**REQUEST FOR PROPOSALS
ADDENDUM No. 3**

Bridge Replacement on US 90
Over St. Louis Bay
Hancock and Harrison Counties, Mississippi

Project No. ER/BR-0003-01(098) 104555/301000 –
US 90 St. Louis Bay Bridge Replacement

Addendum No. 3 Summary

RIGHT-OF-WAY MARKER

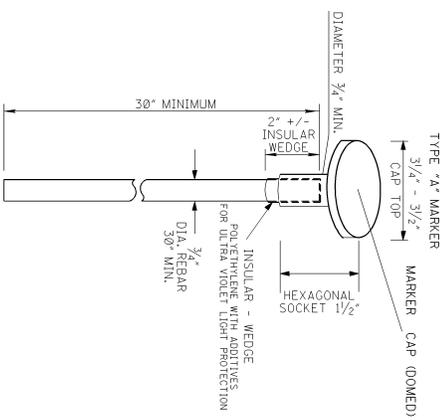
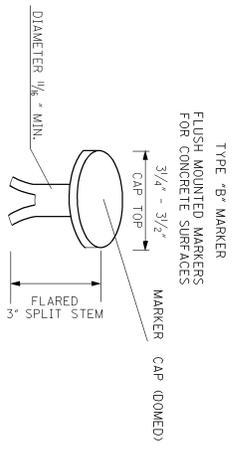
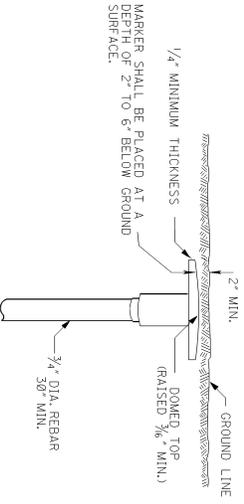
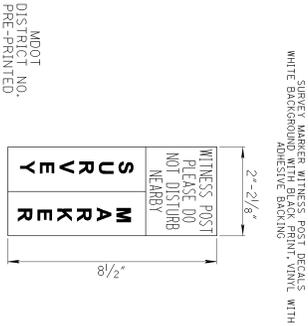
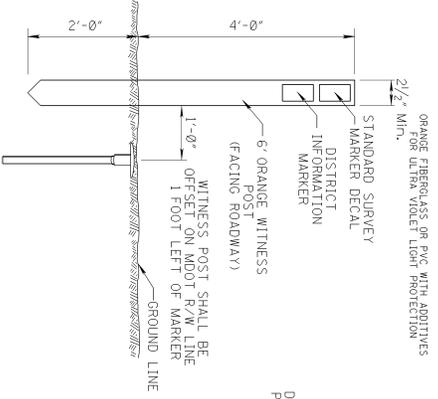
Section 617, Right-Of-Way Markers, of the 2004 Edition of the Mississippi Standard Specifications for Road and Bridge Construction is deleted in toto and replaced as follows:

907-617.03.1--General. Markers shall be manufactured in accordance with the details shown on the plan attached and the requirements of this section.

MARKER CAP SPECIFICATIONS	
PRINT DATA WHERE SHOWN	
3.25" - 3.50" DIAMETER DOME TOP	OUTSIDE ROW
46 SPACES	W/OT - DO NOT DISTURB*
3/8" LETTERS	3/8" LETTERS
W/ODE ROW	3/8" LETTERS
RIGHT OF WAY*	3/8" LETTERS
INSIDE ROW	3/8" LETTERS
35 SPACES	PROJECT ROW # AND INDIVIDUAL MARKER #
3/8" LETTERS	1/8" LETTERS

INDIVIDUAL MARKER NUMBER SHALL BE STAMPED AT THE TIME OF PLACEMENT OF THE MARKER. THE MARKER ROW DIVISIONS LAYOUT AS PROVIDED SHALL BE PRE-STAMPED.
